Response to Reviewer 1

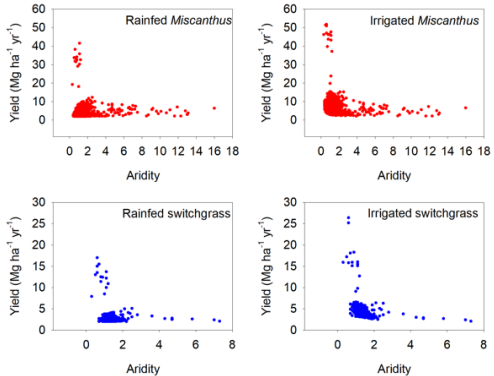
R1C36	<p>Lines 223-233: Is this based on some aggregated regions, or on all the grids that belong to each climate zone? How do these results compare to other studies that were discussed in section 3.4? assuming this was based on a grid-level analysis, why not plot the results for all the grids and show a scatter</p>	<p>This is a very good point. Yes, it is based on all grid cells belonging to specific climate zones. However, we used the results for grid cells with yield higher than 2 Mg ha⁻¹ yr⁻¹ (low-yield productivity). Based on your suggestion, we constructed a scatterplot diagram between yield and</p>

<p>plot (yield on the y-axis, and aridity or some other index that allows for distinguishing among the different climate zones on the x-axis)? This would allow the authors to fit a line to the data and talk about the results in a more compelling way.</p>	<p>aridity (shown below). However, we found it difficult to directly differentiate the effect of climate. Meanwhile, our current figures clearly show the differences among different climate zones. This section provides additional analysis of the predicted yield, which may not affect the main conclusion of this study. Therefore, please let us retain the original presentation of these results.</p> 
R1C37	<p>Line 241: ‘WUE, which is defined in this study as the ratio of yield to water consumption’ This should have appeared the first time the term is mentioned in the manuscript.</p>	<p>We have defined this term in the introduction, as follows (lines 54–55):</p> <p>“5) illustrate the effects of irrigation on the yield, water consumption, and WUE (defined here as the ratio of yield to water consumption) of <i>Miscanthus</i> and switchgrass.”</p>
